ACCESS COMPLIANCE ASSESSMENT REPORT

CHILD DEVELOPMENT INSTITUTE – RESPITE AND EARLY INTERVENTION THERAPY

173 WARRINGAH ROAD, BEACON HILL

REPORT NO. ► 10666

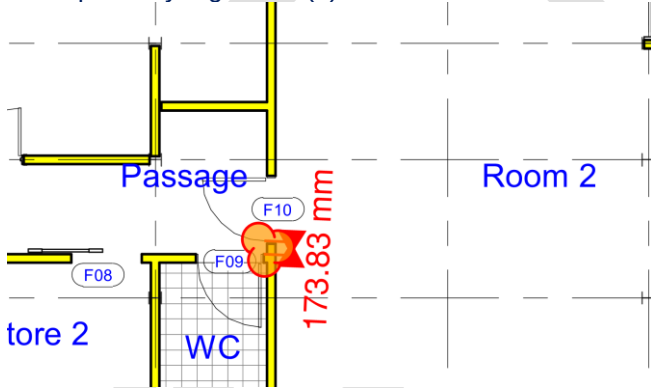
BCA Clause	Deemed-to-Satisfy Provision to be addressed
D3.1 – General building access requirements	- The doorway to the following areas require a clear opening of 850mm as per Clause 13.2 of AS 1428.1-2009: - Level 0 – Sliding doors to playrooms 1, 2 & 3. A single leaf to the double doorways serving the store room and existing laundry located off playroom 1. - Level 1 – Office 1 and meeting room (highlighted in blue below).

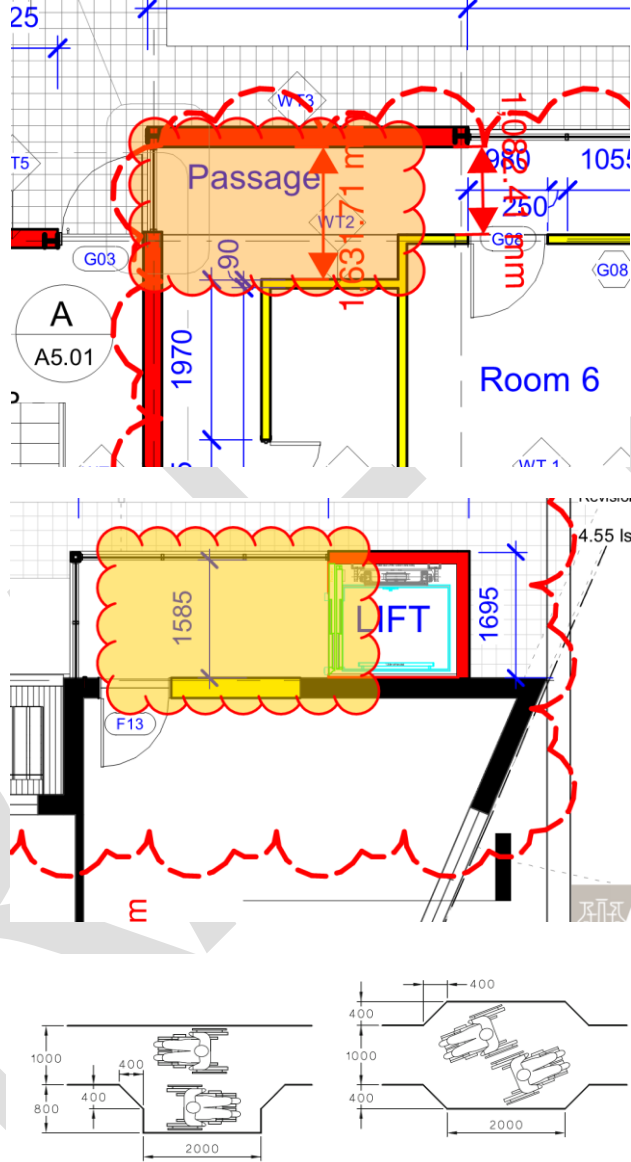
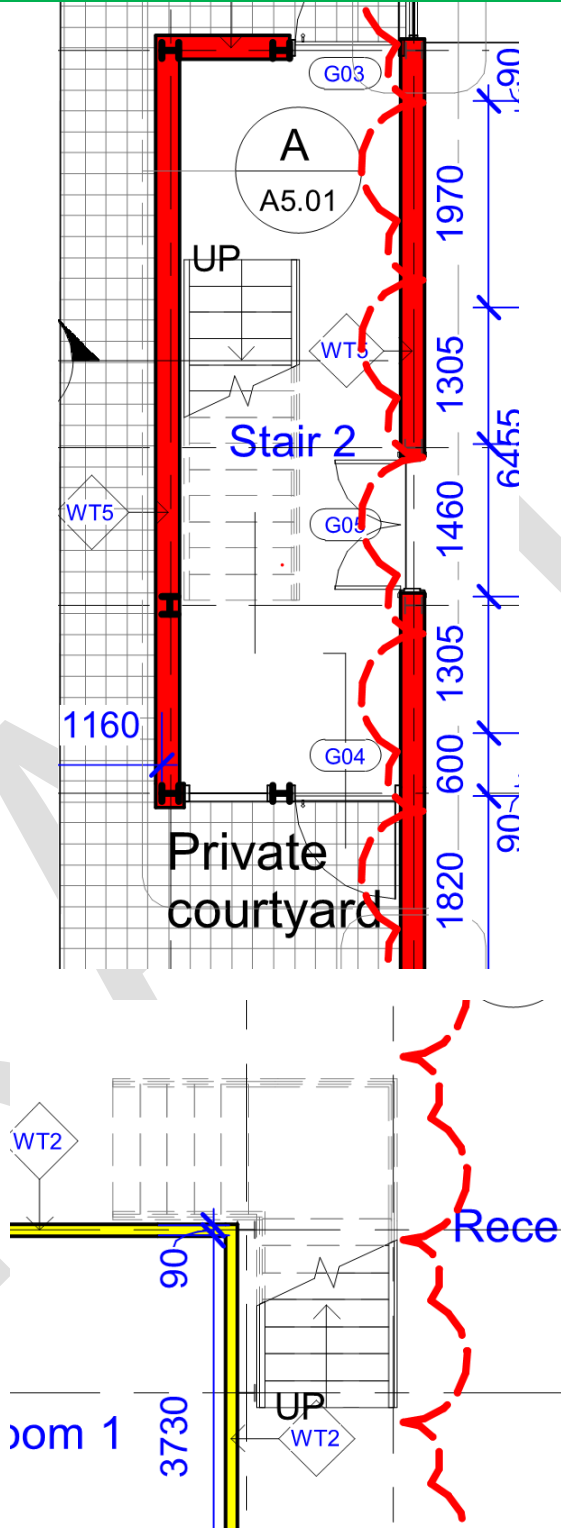
- The sliding doors to office 3, 4 & 5 and store 2 on level 2 are not provided with 530mm latch side clearance as required by Figure 32 (d) of AS 1428.1-2009. It is recommended the doors to office 3 & 4 be swing doors in order to achieve compliance.
The landing outside the doorways to store rooms 2 & 3 and office 5 does not provide the 1450mm landing space (1190mm noted).

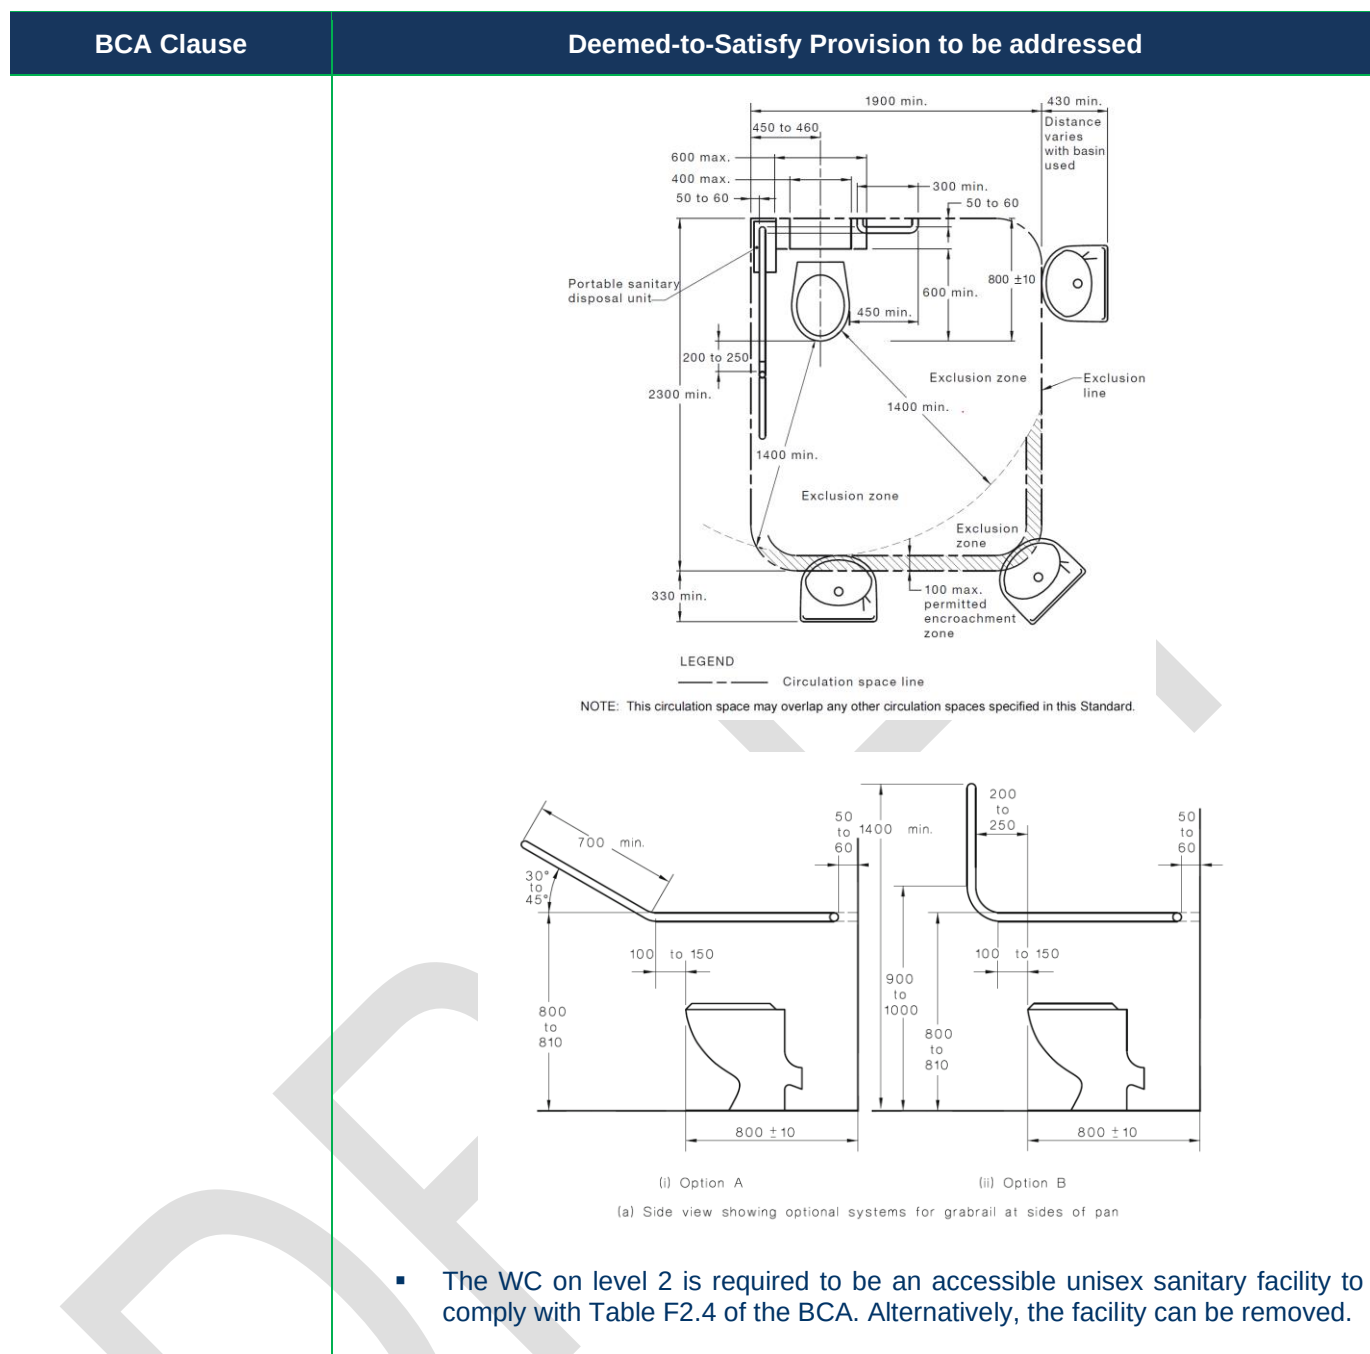
BCA Clause	Deemed-to-Satisfy Provision to be addressed
Parts of buildings to be accessible	A passing space of 1800mm x 2000mm is to be provided to the area along the accessway highlighted below in orange on level 1 and level 2 outside the lift as per Figure 3 of AS 1428.1-2009.  FIGURE 3 EXAMPLES FOR PASSING SPACE FOR WHEELCHAIRS The two (2) non-fire-isolated stairways within the building are to be provided with the following design features as per AS 1428.1-2009: ○ Handrails to both sides of the stairway as per Clause 11.2 (b); ○ The handrail is to extend at least one tread depth + 300mm beyond the bottom riser as per Clause 11.2(d); ○ The handrail is to extend a minimum 300mm beyond the top riser as per Clause 11.2(f).

FIGURE 26(B) STAIRWAY LOCATION AND HANDRAIL EXTENSIONS AT END OF STAIRWAY OTHER THAN AT LINE OF BOUNDARY

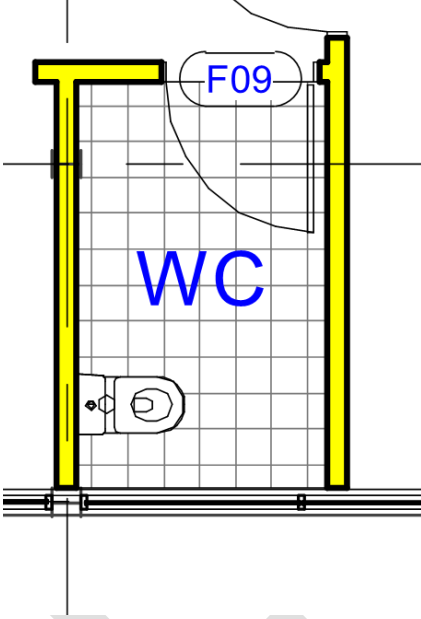
- A turning space of 1540mm x 2070mm is required at the doorway providing access into stair 2 on level 2 as per Figure 5 of AS 1428.1-2009.

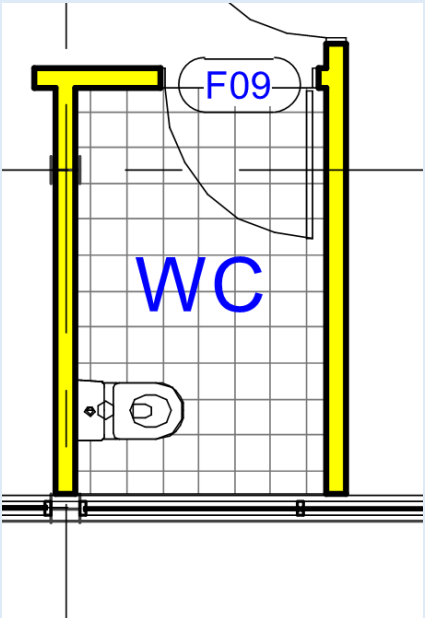
<u>F2.4 - Accessible sanitary facilities</u>		X			<u>Compliance issue:</u> An accessible WC is required to level 0 as per Table F2.4. In order for the sanitary compartment detailed below to comply, an exclusion zone around the WC of 1400mm (or 1300mm to the washbasin) is required as per Figure 43 of AS 1428.1-2009. The WC and grabrails are to be designed to comply with Figure 42 of AS 1428.1-2009. It should be noted, the accessible unisex sanitary facility on level 1 is to comply with the same requirements.
--	--	---	--	--	--
